drawing stage	PLANNING		
Briffa Phillips Architecture Design Planning Consultants Project Management			
19-21 Holywell Hill, St Albans Herts AL1 1EZ Tel. 01727 840567 Fax. 01727 731671 www.briffaphillips.com info@briffaphillips.com

project title			
SITE ADJOINING 33 HOLMDALE ROAD LONDON			
drawing title			
PROPOSED ELEVATIONS & SECTIONS			
scale			
1:100@A1			
job architect			
MB			
drawn			
AC			
checked			
AMS			
date			
09.01.12			
project no.			
1403			
drawing no.			
104			
revision			
E

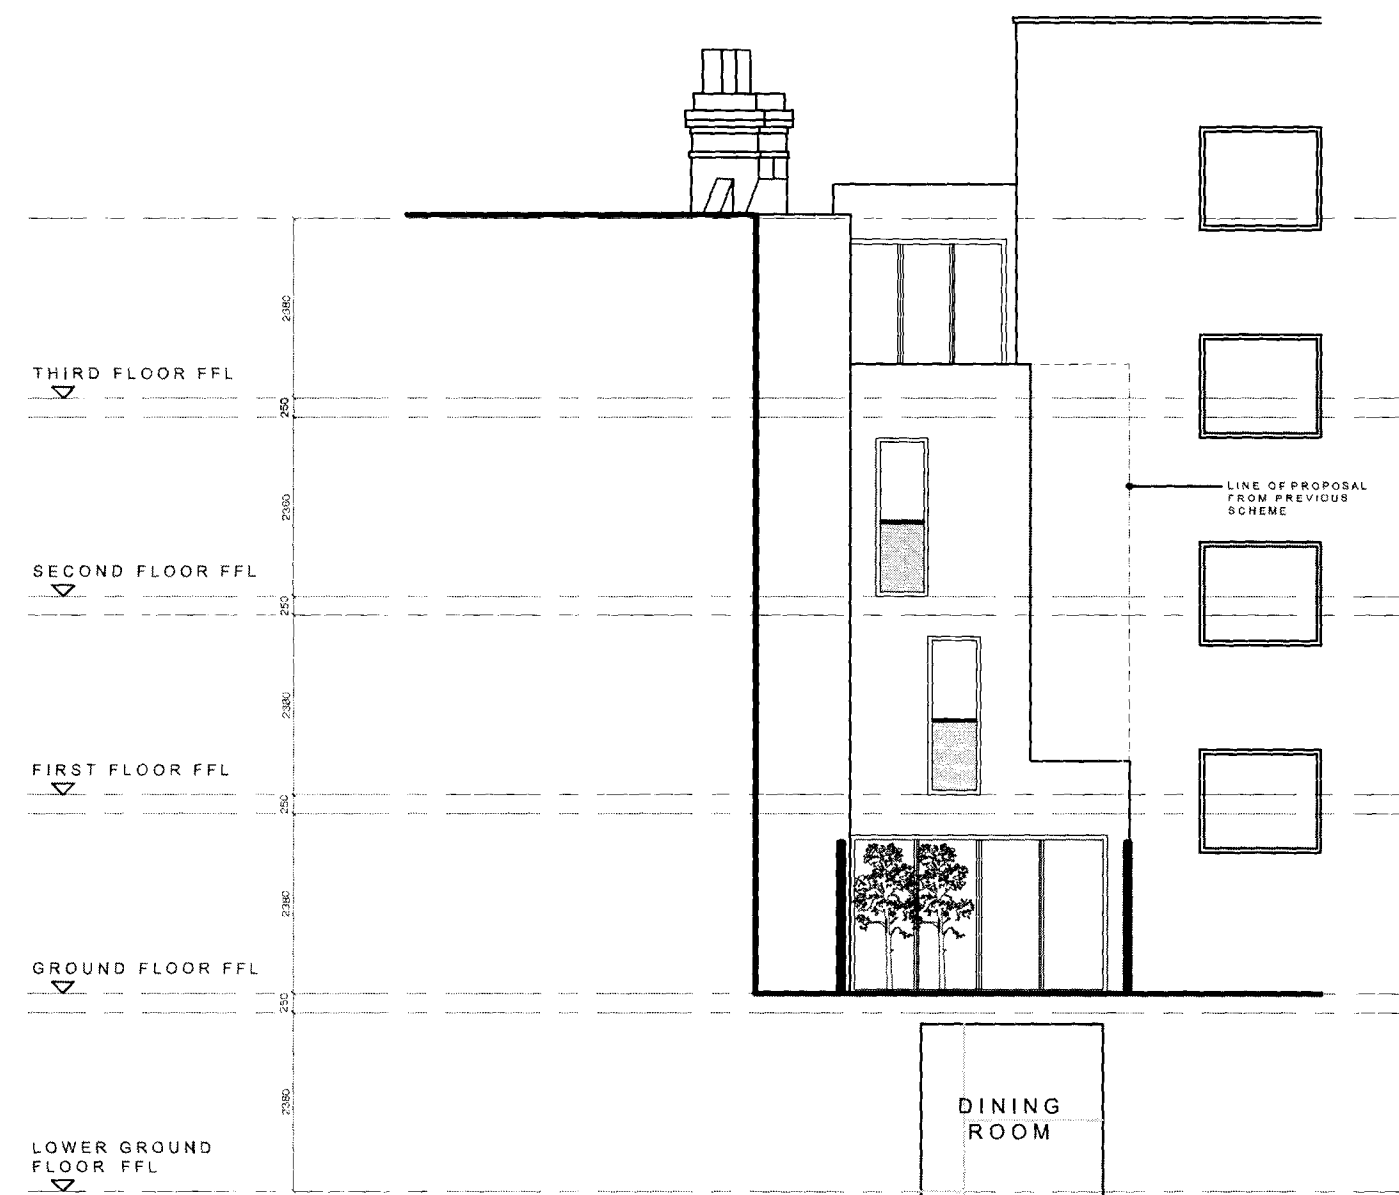
REV.E: AC 05.12.12 - GLAZED STAIRWELL WALL DETAIL AMENDED ON ELEVATIONS. FRONT DOOR, PORCH & WINDOWS REVISED
REV.D: AC 30.11.12 - GLAZED STAIRWELL WALL DETAIL AMENDED ON ELEVATIONS. FRONT DOOR & PORCH REVISED
REV.C: AC 22.08.12 - GREEN ROOF REMOVED FROM FRONT ELEVATION. WINDOWS ON FRONT ELEVATION AMENDED TO RELATE TO HORIZONTAL 'BANDING'. OUTLINE OF STAIRCASE FROM PREVIOUS SCHEME SHOWN. OUTLINE OF REAR ELEVATION FROM PREVIOUS SCHEME ADDED
REV.B: AC 20.07.12 - ELEVATIONS & SECTIONS REVISED TO SUIT UPDATED FLOOR PLANS. KEY PLAN REVISED
REV.A: AC 14.02.12 - MINOR AMENDMENTS TO COMPLY WITH LIFETIME HOME STANDARDS AND SUSTAINABLE DESIGN REQUIREMENTS
